To All Lamborghini Dealers and Licensed Service Point
From Customer Service Department
Subject Rear drive shafts
Group 140.3.07
Date 17.05.2007
Pages 6

Subject
Rear drive shafts

Model / VIN-Range
Gallardo (Coupè and Spyder) from VIN 4460 to VIN 5690

Pic. 2

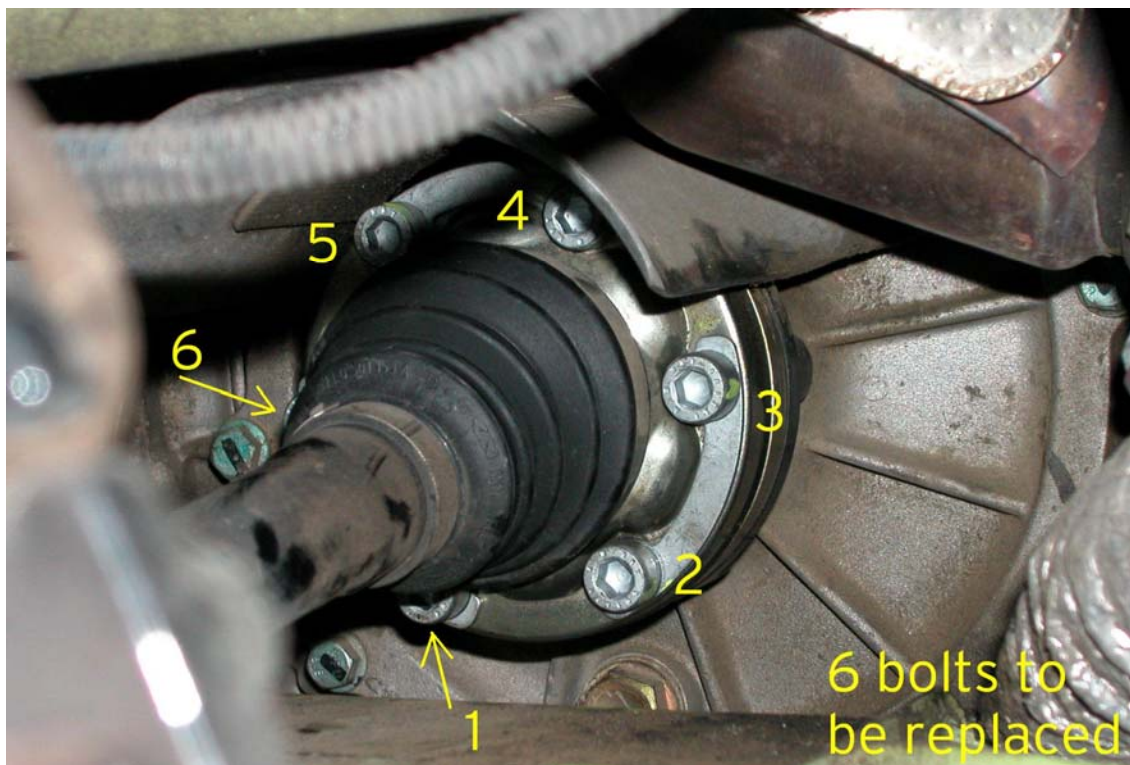
- 1.5** As shown in picture 2, you have to replace all the 6 bolts on the shaft on both transmission side, totally 12 bolts per car.

- 1.6** Unscrew all the six bolts on the driveshaft.
- 1.7** Replace the old bolts with the new ones of the rework kit 0R1400150. The kit contains 12 bolts.

Pict. 3

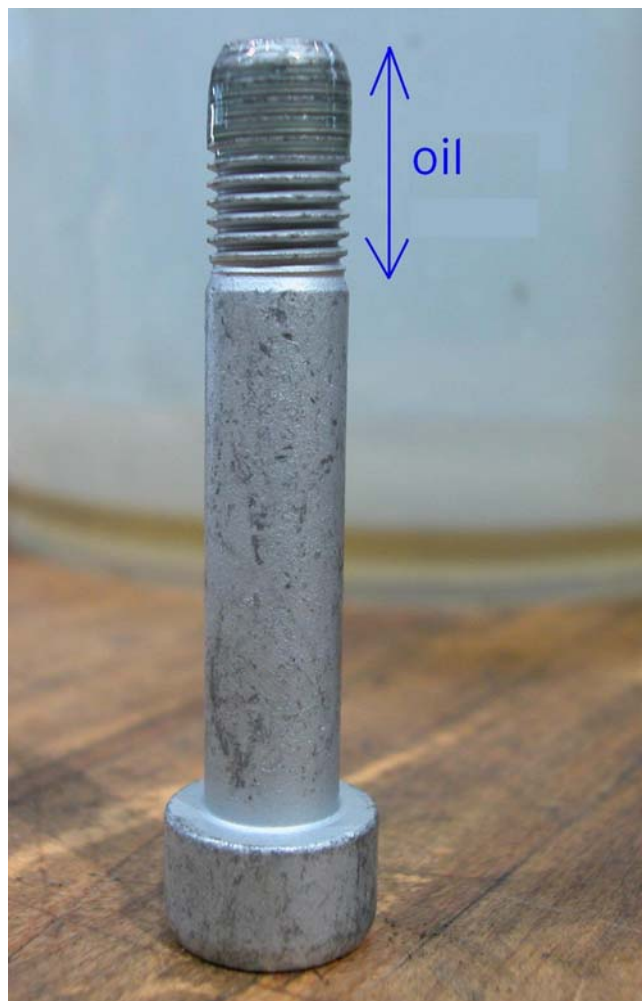
1.8 You have to oil the bolt thread, (as shown in picture 3), with oil of one of the following types:

- Agip Sint 2000 Evolution SAE 5W/40
- Agip TecSint
- Castrol TXT Softec SAE 5W/40

Pict. 4

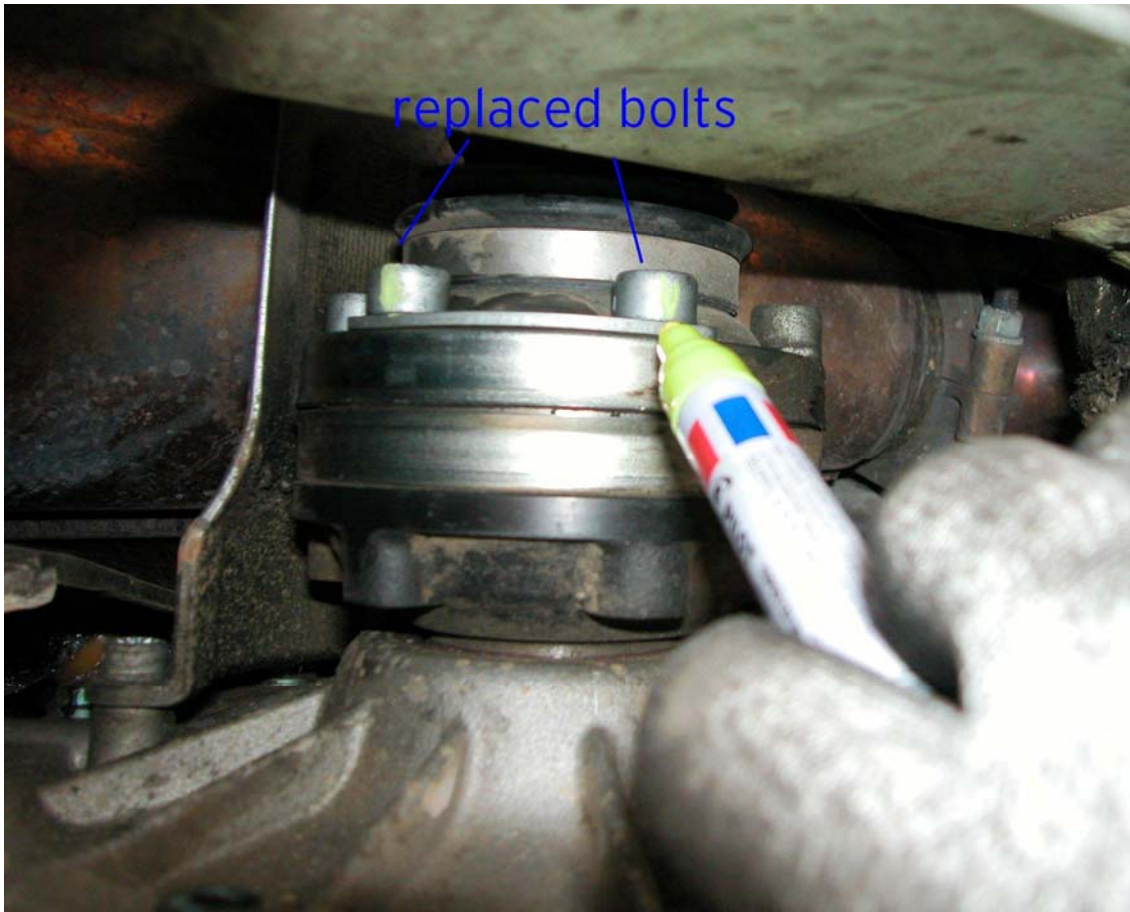
1.13 Make a yellow mark on the replaced bolts as shown in picture 4.

1.11 Pre-torque all the six bolts on the same driveshaft at 15 Nm.

1.12 Then tighten all the six bolts at 75 Nm.
